Access Compliance Report

Public Rights-of-Way

Intersection ID: 43497	Main Street: DALTREY_LN	Cross Street: CARANNA_CT	Location: SE
ADA ID: FC3376C61390	Ramp Type: PerpDiag	Initial Pass/Fail: Fail	Overall Compliance: No
Severity Score: 8.75			
Codes/Mitigation Info/Possible Solution		Field Measurements/Component Compliance

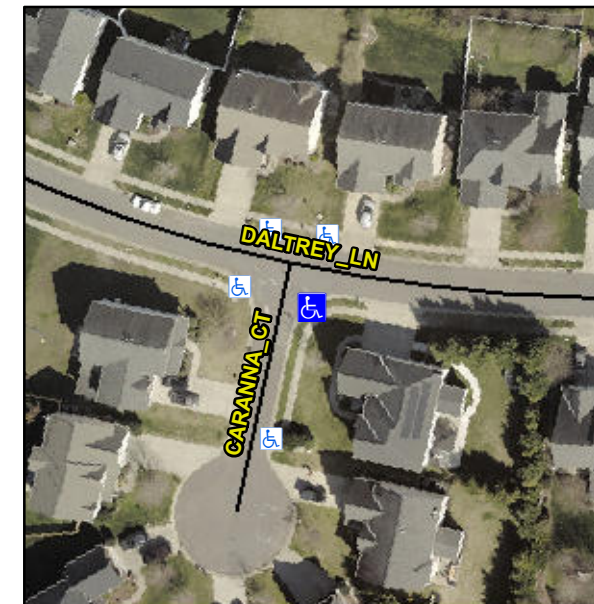
Not Found, R304.5.1

Compliance	Description	Data	Compliance	Description	Data
N/A	Ramp Length (in)	48.0	Yes	Ramp Slope (%)	5.1
No	Ramp Width (in)	38.0	Yes	Ramp XSlope (%)	1.0
N/A	Flare Type LT	N/A	N/A	Flare Type RT	N/A
N/A	Flare Slope LT (%)	N/A	N/A	Flare Slope RT (%)	N/A
N/A	Flare Traversable LT?	N/A	N/A	Flare Traversable RT?	N/A
N/A	Landing Length (in)	N/A	N/A	DWS Provided?	N/A
N/A	Landing Width (in)	N/A	N/A	DWS Contrast?	N/A
N/A	Landing Slope (%)	N/A	N/A	DWS Length (in)	N/A
N/A	Landing X Slope (%)	N/A	N/A	DWS Full Width?	N/A
N/A	Landing Curb? (Y/N)	N/A	N/A	DWS Offset (in)	N/A
N/A	Shared Landing?	N/A			
N/A	Gutter Ponding?	N/A	N/A	Gutter Slope (%)	N/A
N/A	Gutter Lip Ht (in)	N/A	N/A	Gutter X Slope (%)	N/A
N/A	Painted X Walk1?	No	N/A	Painted X Walk2?	No
	X Walk 1 Direction	To NE		X Walk 2 Direction	To NW
N/A	X Walk 1 Width (in)	N/A	N/A	X Walk 2 Width (in)	N/A
	X Walk 1 Slope (%)	1.8		X Walk 2 Slope (%)	1.7
	X Walk 1 X Slope (%)	1.6		X Walk 2 X Slope (%)	2.9

Remove & Replace Curb Ramp With Two New Directional Ramps or Equivalent.
